### **ADDENDUM NUMBER 5**

- 1.01 DATE: MARCH 31, 2021**
- 1.02 PROJECT: WELCOME CENTER**
- 1.03 PROJECT NUMBER: DCM NO. 2020604**
- 1.04 OWNER: ALABAMA A&M UNIVERSITY**
- 1.05 ARCHITECT: NOLA | VAN PEURSEM ARCHITECTS, PC**

**4.03 SHEET A-7.3 – WALL SECTIONS**

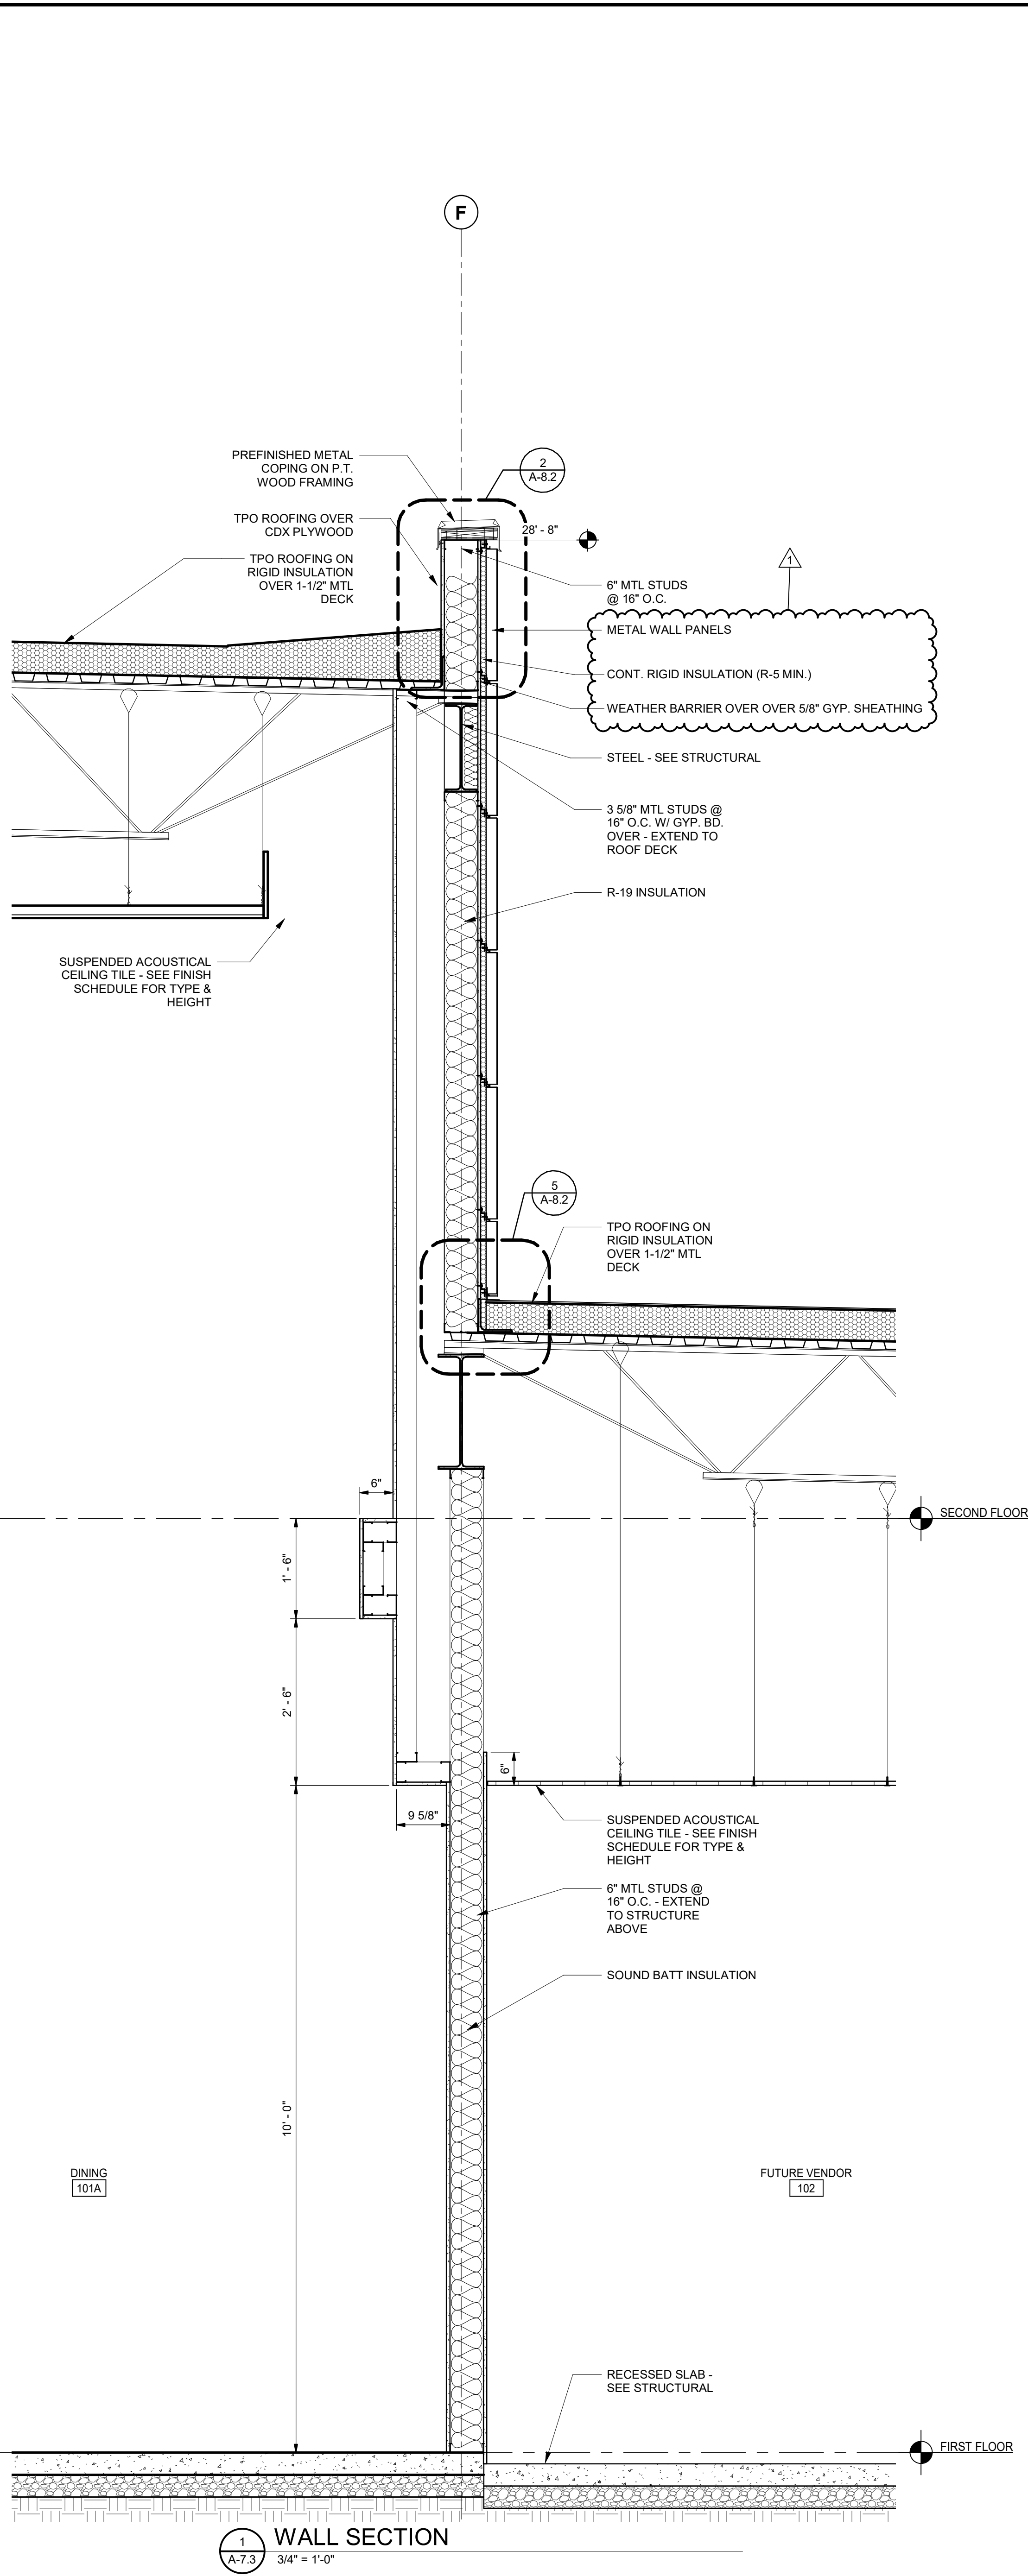
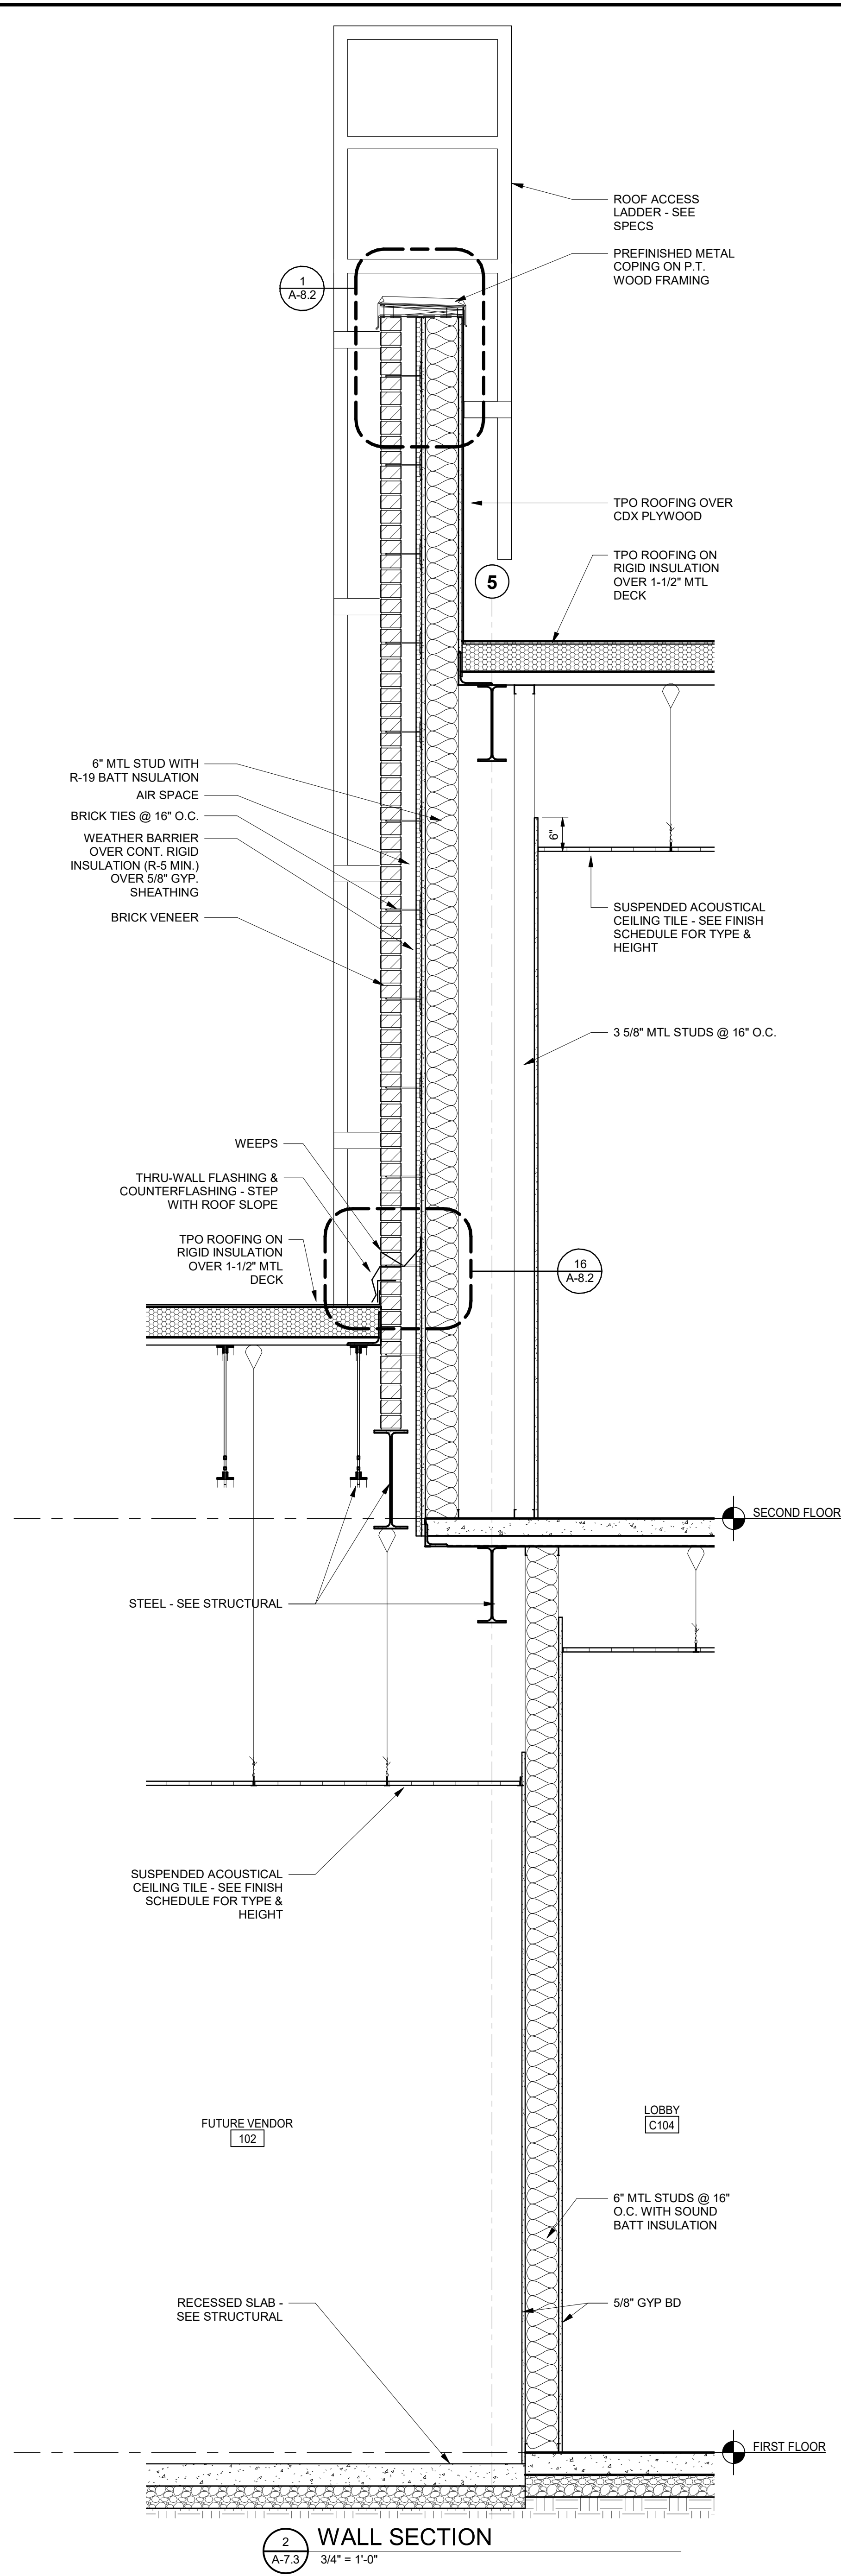
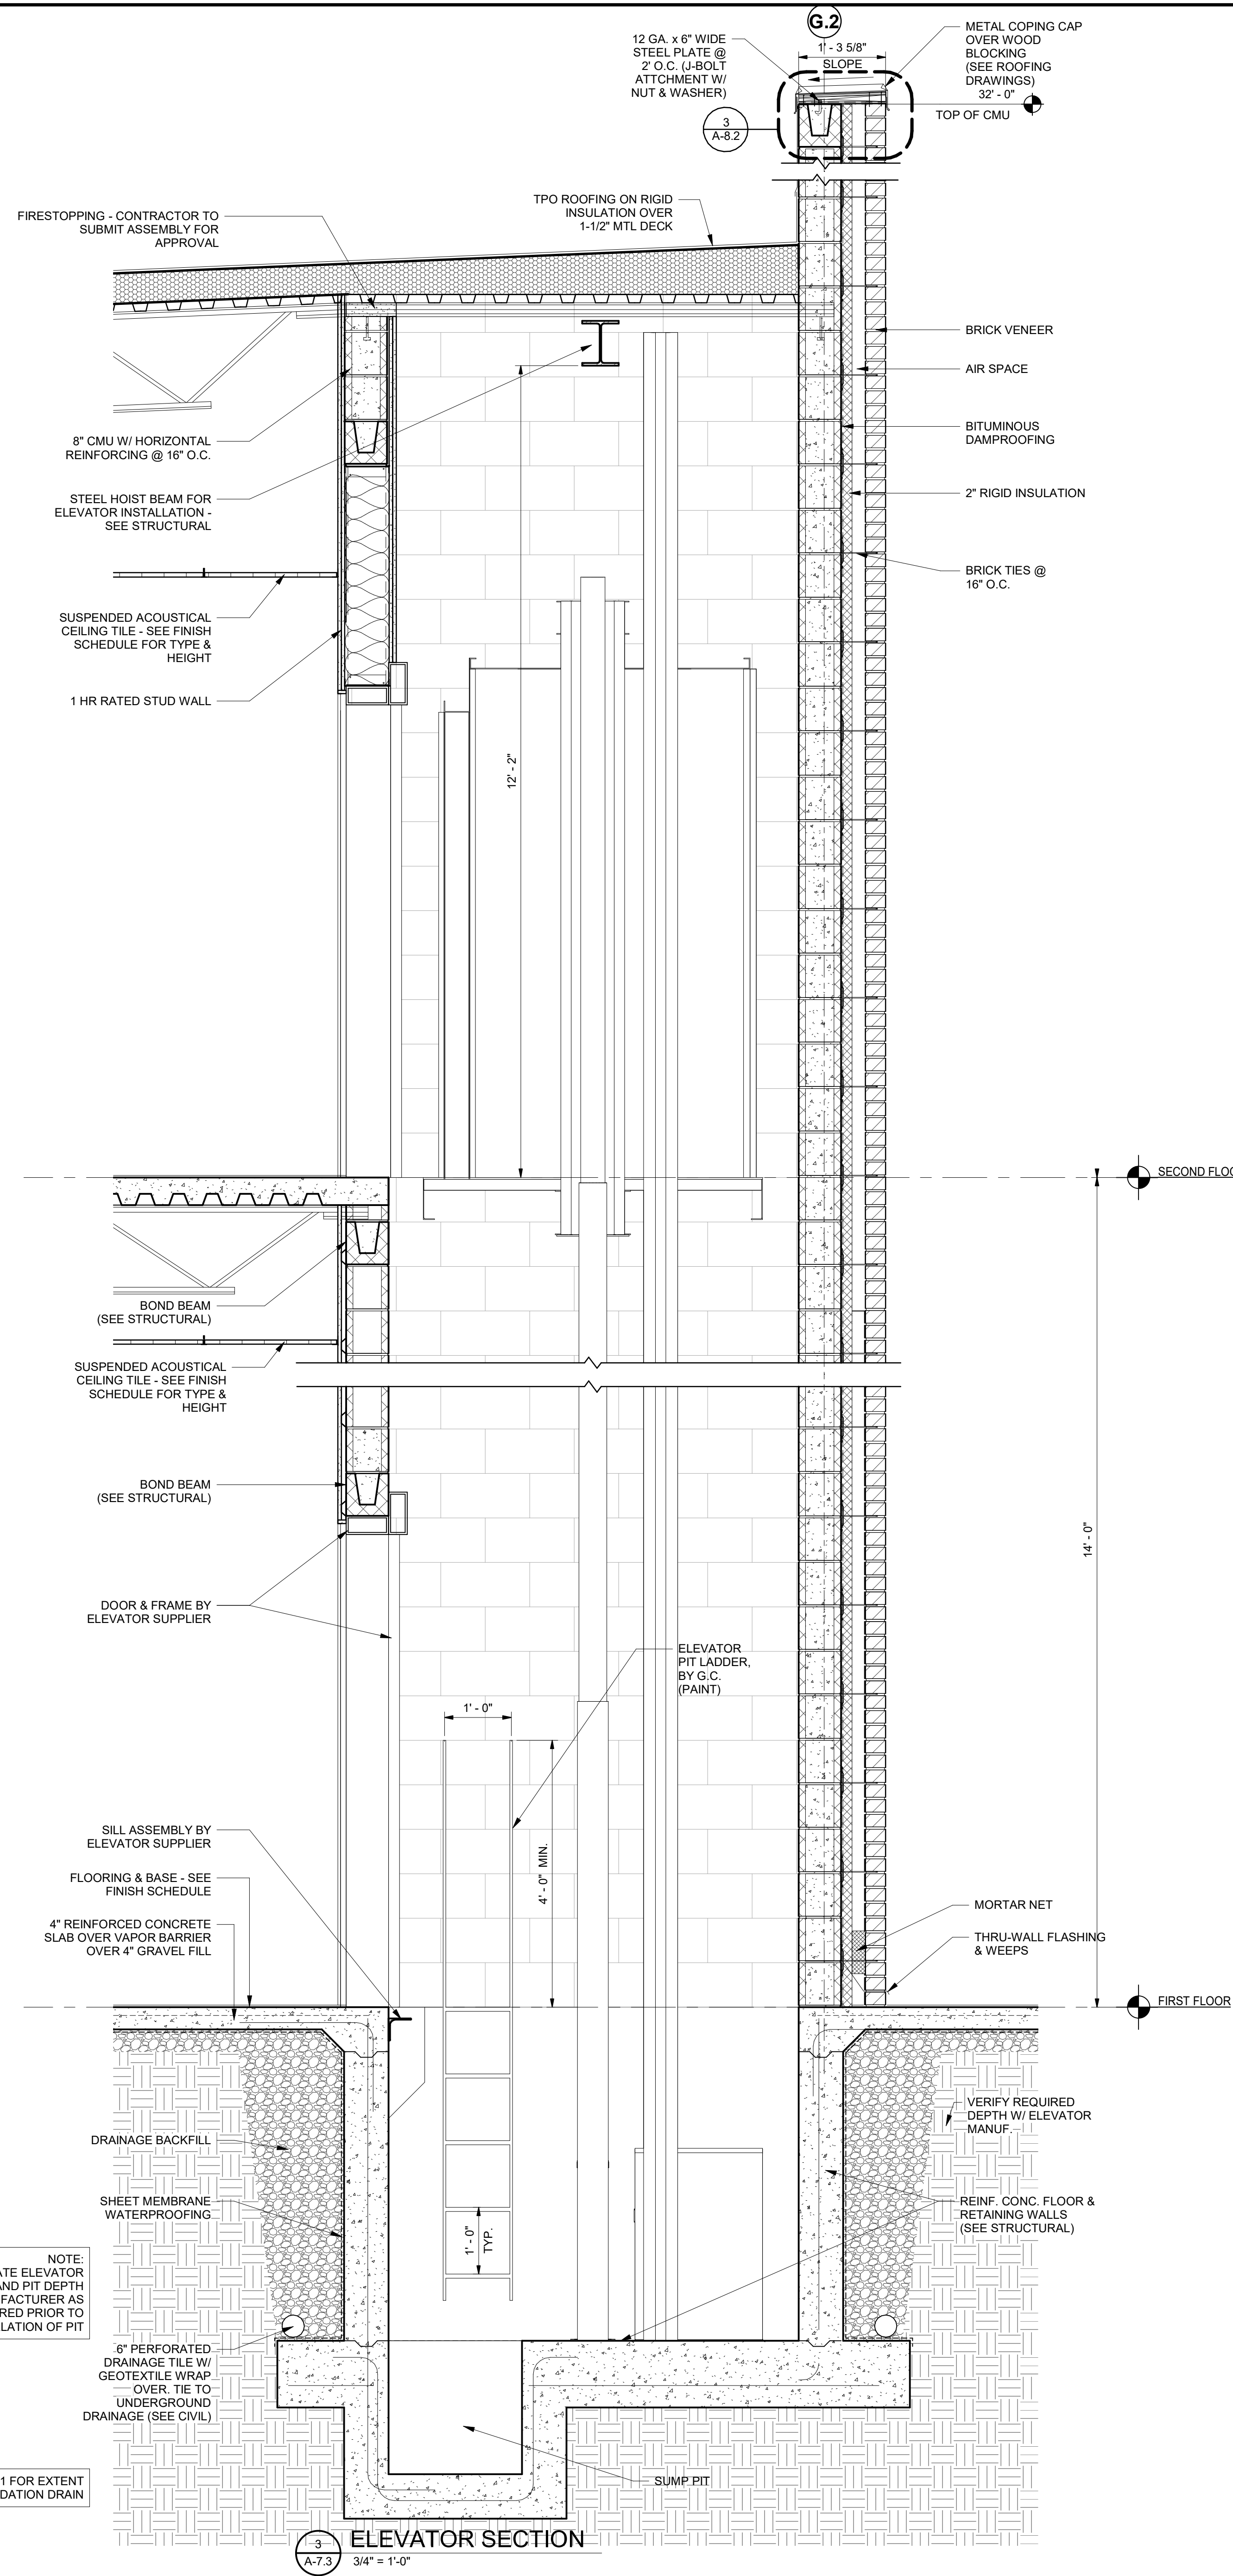
- A. Replace this sheet in its entirety. Revisions include the following:
  - 1. Updated notes to add weather barrier.
